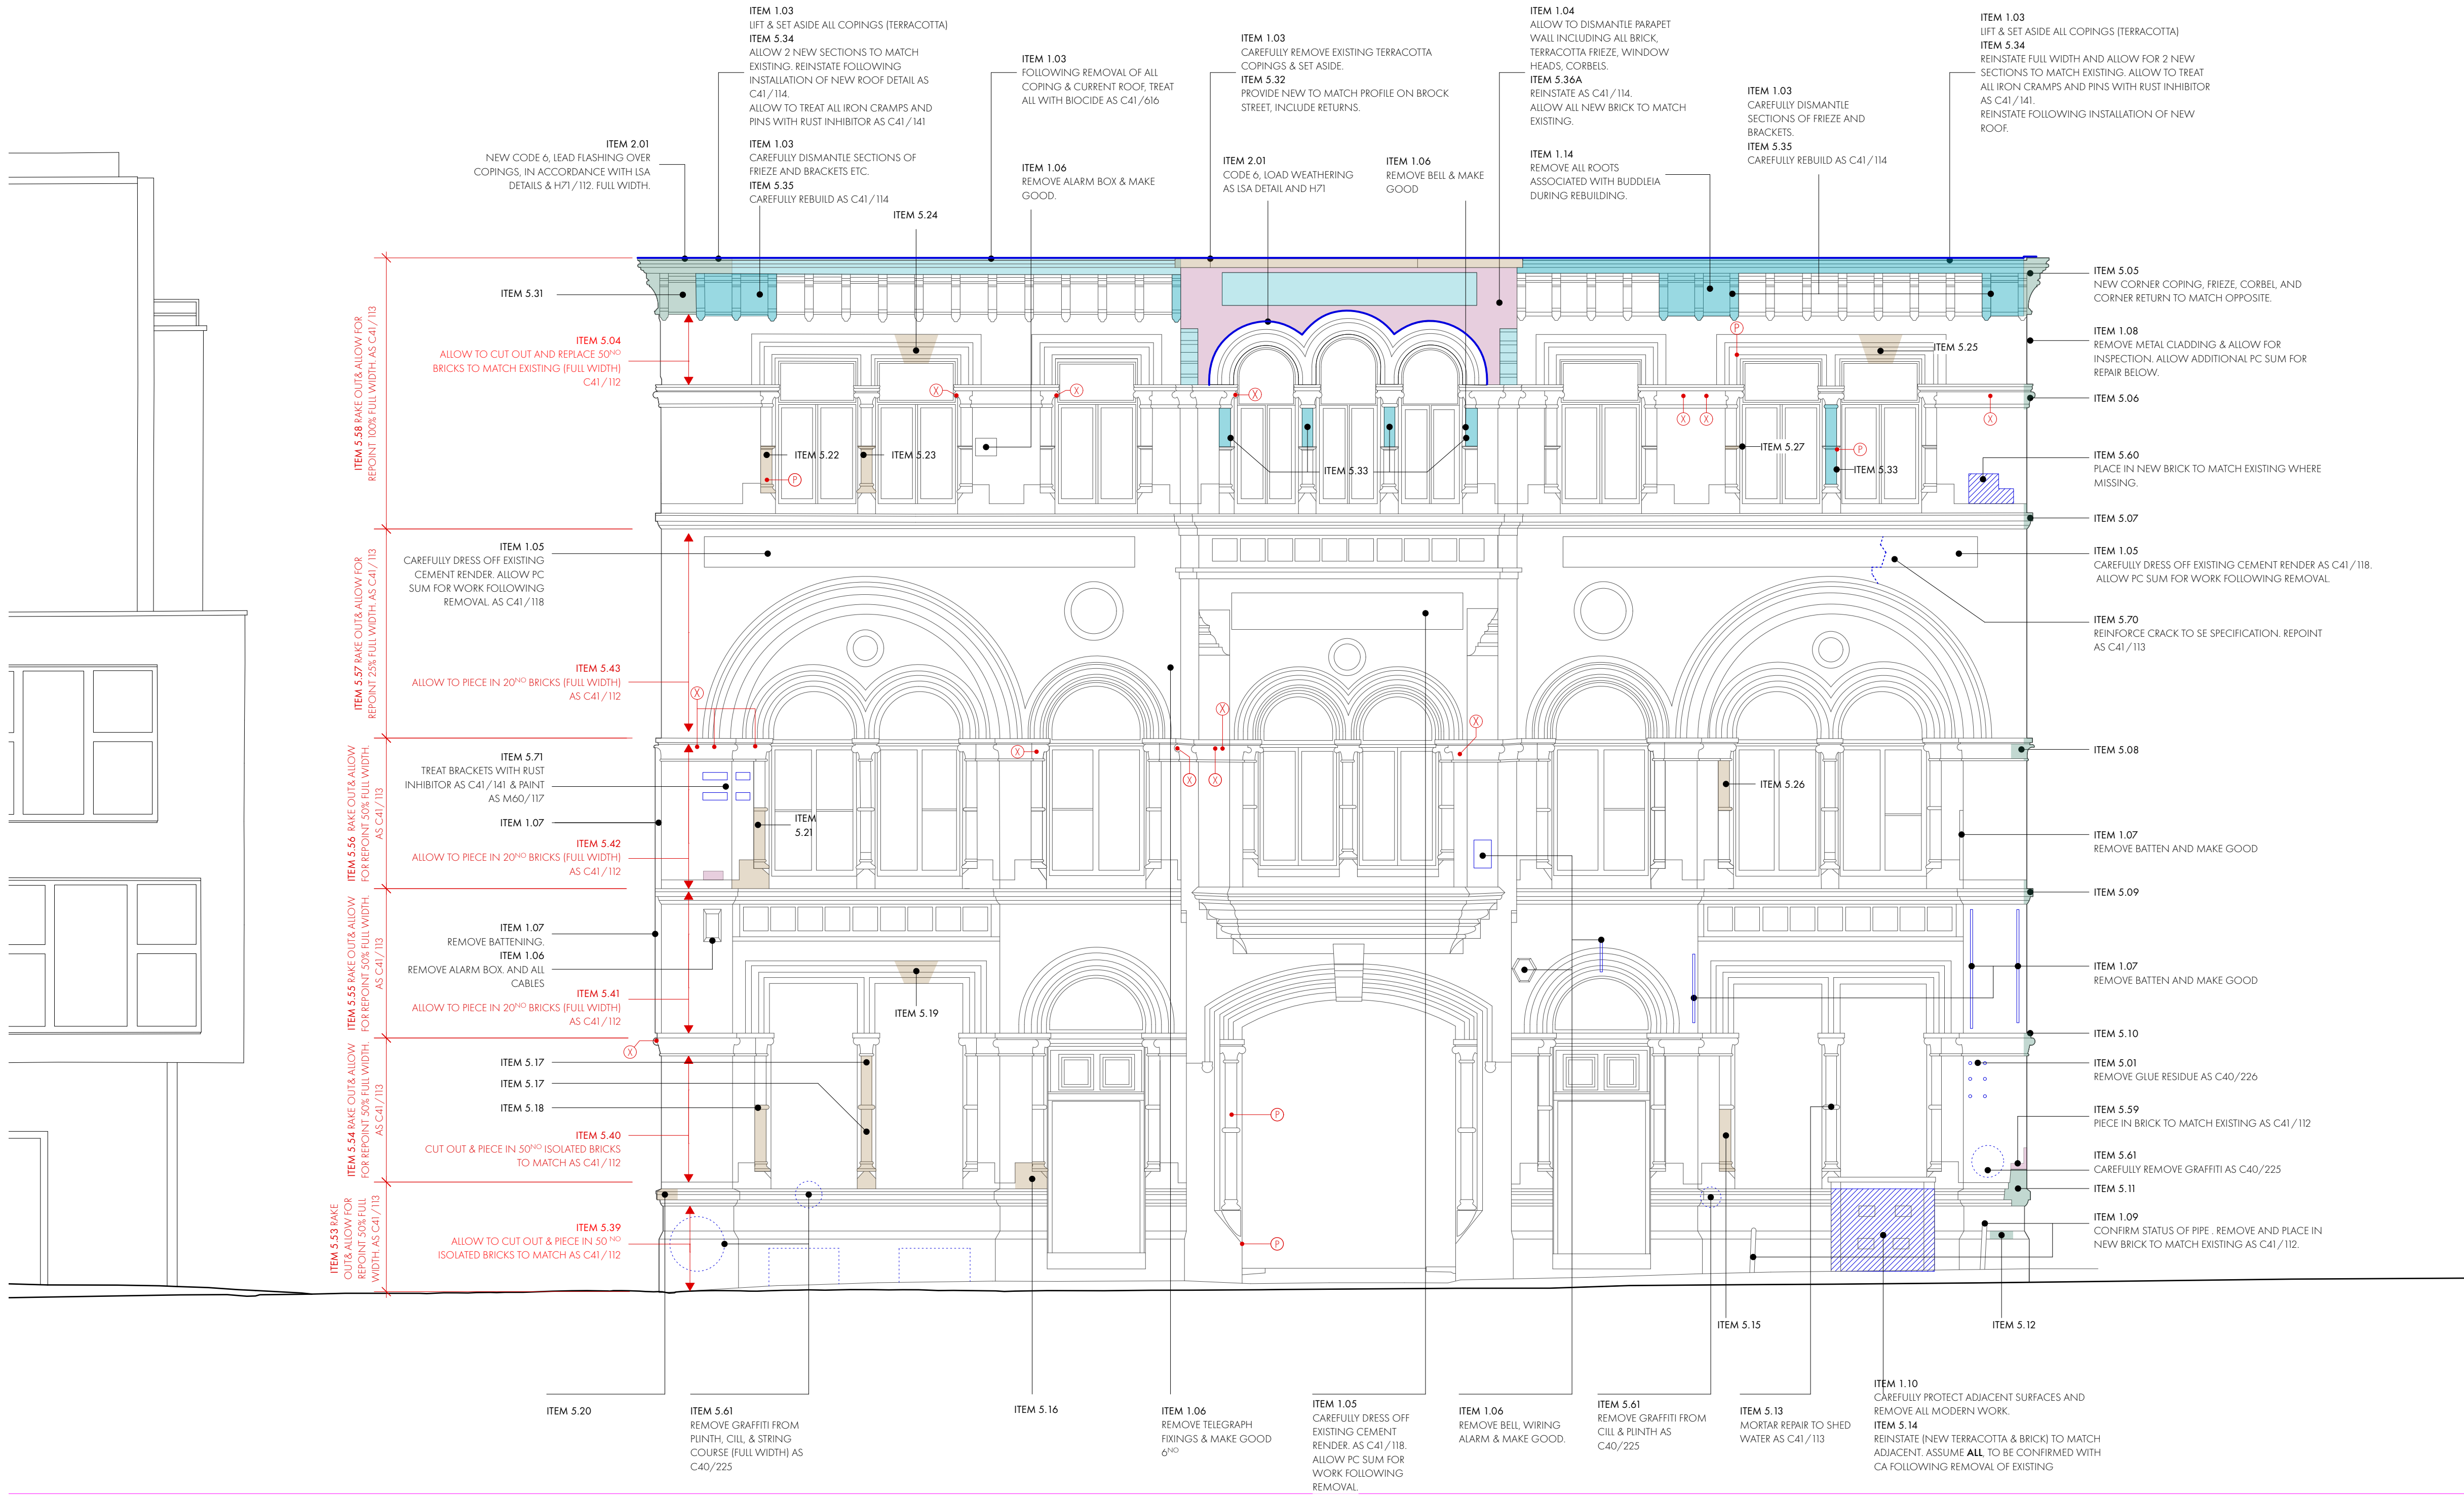
- CAREFULLY DISMANTLE TERRACOTTA COPING TO CORNICE, INSPECT & ALLOW TO REBUILD, ALLOW PC SUM FOR RENEWAL AND REPAIRS AS STATED. AS C41 /114.
- CAREFULLY DISMANTLE/ REMOVE EXISTING TERRACOTTA. (WHERE APPLICABLE) PROVIDE NEW TO MATCH EXISTING. (OR AS STATED) AS C41 /115

- CAREFULLY DISMANTLE, ALLOW TO REBUILD BRICKWORK/ ALLOW FOR RENEWAL AS STATED C41 /112.
- TERRACOTTA MISSING. PREPARE AND PROVIDE NEW SECTION AS C41 /121 (I WILL REQUIRE PATTERN)

- ITEM 2.01
NEW CODE 6 LEAD FLASHING/ WEATHERING AS H71 /112
- ITEM 5.02
CAREFULLY REMOVE PIN CRACKED TERRACOTTA (SUBJECT TO SITE TRIAL) AS C41 /119 & REINSTATE.

- ITEM 5.03
MISSING ACANTHUS LEAF DETAIL (SINGLE) REMOVE EXISTING PIN (IRON). PROVIDE NEW TERRACOTTA DETAIL AND RE ADD USING STAINLESS DOWEL AS C41 /120.

- ITEM 1.15
REMOVE **ALL** METAL GRILLES & METAL ROLLER SHUTTER, & MAKE GOOD. ALLOW ADDITIONAL PC SUM FOR REPAIR FOLLOWING REMOVAL.
- ITEM 5.04
CAREFULLY REMOVE PIN CRACKED TERRACOTTA (SUBJECT TO SITE TRIAL) AS C41 /119 & REINSTATE.
